Access Compliance Report

Public Rights-of-Way

(Curb Ramps)

Intersection ID: 52688	Main Street: CITY_PARK_DR	Cross Street: ARBOR_LOOP_DR	Location:	N
ADA ID: 2E97526B385B	Ramp Type: Perp	Initial Pass/Fail: Fail	Overall Compliance: No	Severity Score: 1.25
Codes/Mitigation Info/Possible Solution		Field Measurements/Component Compliance

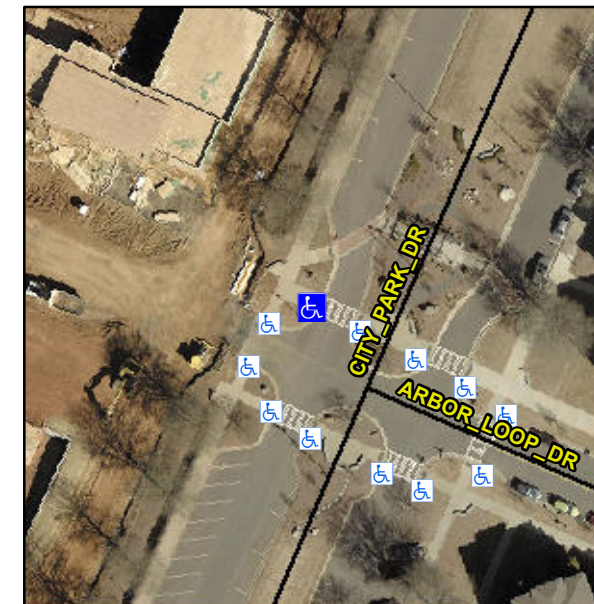
R304.5.3

Compliance	Description	Data	Compliance	Description	Data
N/A	Ramp Length (in)	53.0	Yes	Ramp Slope (%)	6.1
Yes	Ramp Width (in)	120.0	No	Ramp XSlope (%)	2.4
N/A	Flare Type LT	N/A	N/A	Flare Type RT	N/A
N/A	Flare Slope LT (%)	N/A	N/A	Flare Slope RT (%)	N/A
N/A	Flare Traversable LT?	N/A	N/A	Flare Traversable RT?	N/A
N/A	Landing Length (in)	N/A	N/A	DWS Provided?	N/A
N/A	Landing Width (in)	N/A	N/A	DWS Contrast?	N/A
N/A	Landing Slope (%)	N/A	N/A	DWS Length (in)	N/A
N/A	Landing X Slope (%)	N/A	N/A	DWS Full Width?	N/A
N/A	Landing Curb? (Y/N)	N/A	N/A	DWS Offset (in)	N/A
N/A	Shared Landing?	N/A			
N/A	Gutter Ponding?	N/A	N/A	Gutter Slope (%)	N/A
N/A	Gutter Lip Ht (in)	N/A	N/A	Gutter X Slope (%)	N/A
N/A	Painted X Walk1?	Yes	N/A	Painted X Walk2?	N/A
	X Walk 1 Direction	To SE		X Walk 2 Direction	N/A
N/A	X Walk 1 Width (in)	111.0	N/A	X Walk 2 Width (in)	N/A
	X Walk 1 Slope (%)	2.7		X Walk 2 Slope (%)	N/A
	X Walk 1 X Slope (%)	3.7		X Walk 2 X Slope (%)	N/A

Remove & Replace Entire Ramp.
